**Re: Case No. 20-1679-EL-BGN - In the Matter of the Application of Pleasant Prairie Solar Energy LLC for a Certificate of Environmental Compatibility and Public Need to Construct a Solar-Powered Electric Generation Facility in Franklin County, Ohio.**

**Response to Sixth Data Request from Staff of the Ohio Power Siting Board**

**PLEASANT PRAIRIE SOLAR ENERGY LLC 'S  
RESPONSE TO THE SIXTH DATA REQUEST  
FROM THE STAFF OF THE OHIO POWER SITING BOARD**

# Geological Features Map

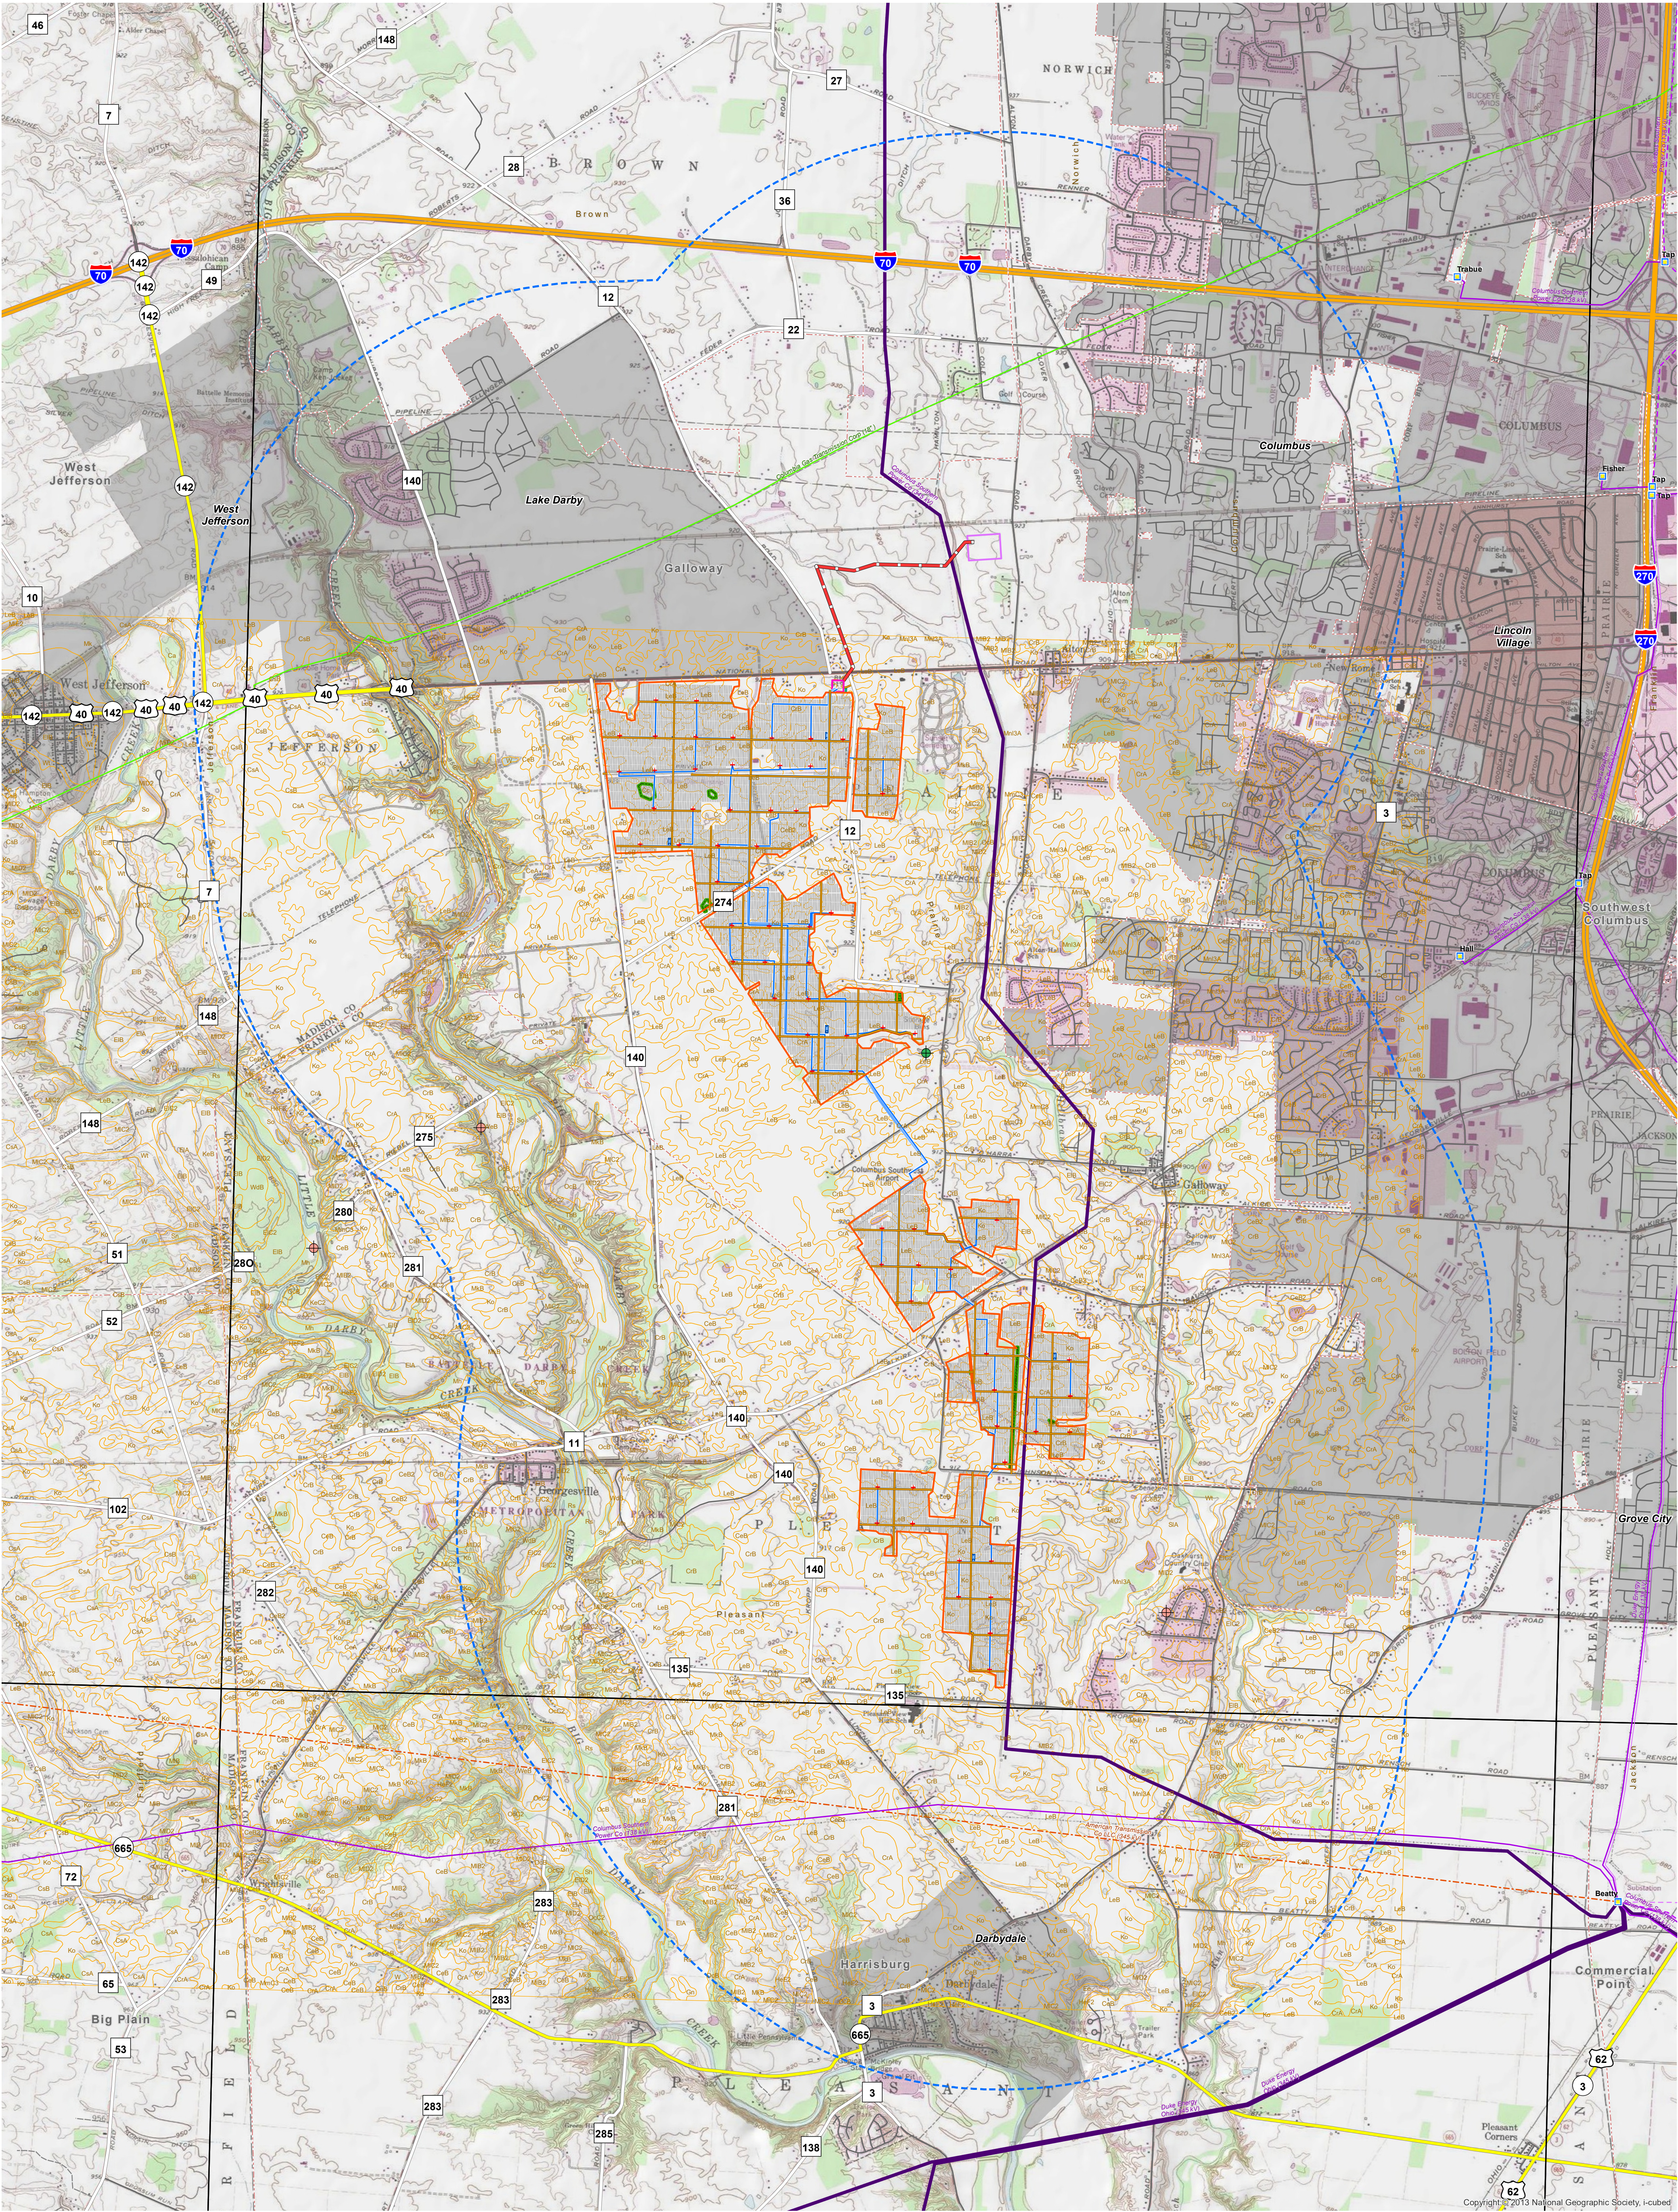
7. **In reviewing Figure 08-1, oil and gas well locations in particular, it appears the Applicant didn't account for a plugged oil and gas well near Alton Road. API #34049600090000. Please confirm the existence of this well by revising the application accordingly. Also, please include the distance of this well from the nearest proposed solar equipment.**

**Response:** This well is plugged and abandoned and below grade (covered by active agricultural area). The Well is located on parcel #1165754839, which is an easement parcel and outside the Project fence line; see Attachment 1 that includes a revision to Figure 08-1. Attachment 1 replaces and supersedes Figure 08-1 that was filed with the Application on February 19, 2021. The well is 244 feet south of the fence line and 1,500 feet east of the planned easement through the parcel.
